4. TIME-LIMITED AGING ANALYSES

4.1 Identification of Time-Limited Aging Analyses

Figure 1

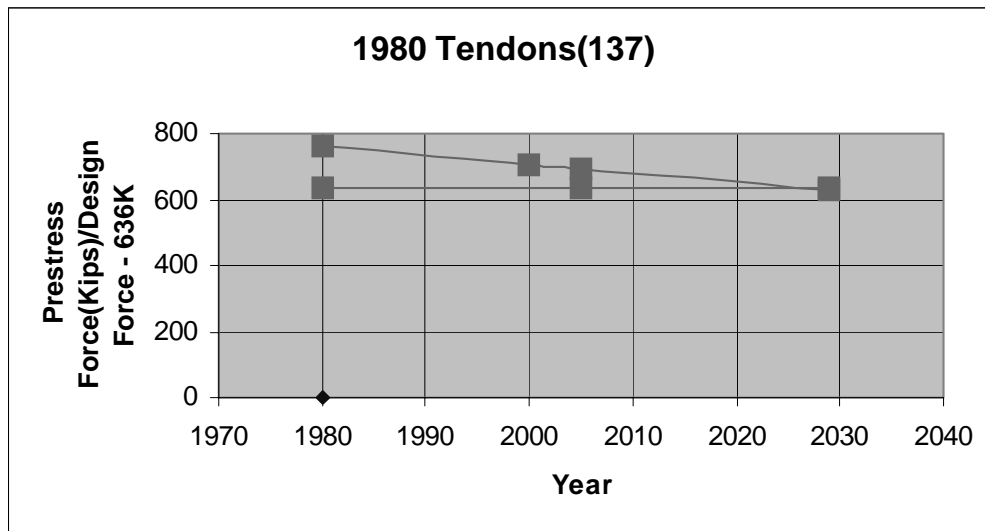
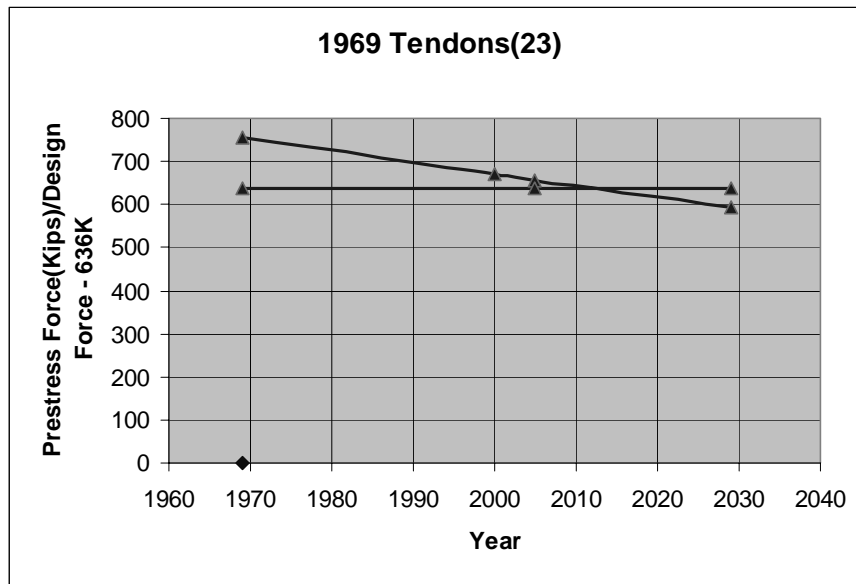
In addition to the review of Section 4.5 of the LRA, the staff reviewed the relevant information in Sections 2.4.1, 3.6, B2.1.3, B3.3, and Section 4.7.4 of the LRA. In the earlier years (1979—1980), the applicant had experienced lower prestressing forces than the minimum required value (MRV) estimated at 40 years. In order to understand the present state of the prestressing forces in the Ginna containment, the staff requested that the applicant provide the following additional information in RAI 4.5-1:

- a) For the 137 tendons which were retensioned in 1980, the applicant is requested to provide the predicted lower limit line, MRV expected in 2005 and at 60 years (if not retensioned in 2005), a trend line for this group of tendons, and prestressing force values as points above and below the trend line measured during prior inspections.

- b) The applicant is requested to provide the same information for the remaining 23 tendons for the inspections performed after 1969 retensioning.
- c) In the operating experience element of Section B3.3 of the LRA, it indicates that 23 tendons out of 160 tendons were retensioned 1000 hours after initial prestressing. It is not clear if the 23 tendons retensioned after initial prestressing were parts of the randomly selected tendons in the subsequent surveillance of tendons performed as per Regulatory Guide 1.35, or IWL-2520. The applicant is requested to provide information regarding the trending of prestressing forces in these 23 tendons.

The staff notes that in constructing the trend lines, it appears that the analyst has averaged the prestressing forces measured during each inspection. In Information Notice 99-10, the staff discouraged the averaging method. The regression analysis is more representative when each measured value is independently considered and the individual measured values are plotted on both sides of the trend line. The applicant was requested to show the individual measured values obtained during each inspection.

- a) Based on the available test information for this set of 137 tendons that were retensioned in 1980, the below graph shows the trend line from 1980 projected through 2005, and out to 2029. The graph also includes a constant line at 636 kips, which is the minimum design prestress force.

b) Based on the available test information for this set of 23 tendons that were retensioned in 1969, the below graph shows the trend line from 1969 projected through 2005, and out to 2029. The graph also includes a constant line at 636 kips, which is the minimum design prestress force.

In the applicant's response dated July 16, 2003, the applicant provided the trend line based on the regression analysis of the measured tendon forces for the inspections performed after 1980 retensioning. On the basis of its review, the staff finds the process used in the trending analysis acceptable as it takes into account the contribution of all measured tendon forces in the regression analysis to arrive at the trend line. The staff considers the issue relative to RAI 4.5-1 to be resolved.

The required minimum design prestress force for the containment structure of Ginna Station is 636 Kips. Based on data compiled for all tendons since 1969, the graphs presented in response to F-RAI 4.5.1 a) and 4.5.1 b) above, show the projected values for the 1969 and 1980 populations of tendons out to years 2005 and 2029. The prestress values for those two groups of tendons will provide a 4% and 8% margin above the minimum design force in 2005, and would fall below the minimum force if projected out to 2029. The tendons in the 1969 population will be retensioned in the 2005 surveillance and those in the 1980 population will be done in subsequent surveillances.
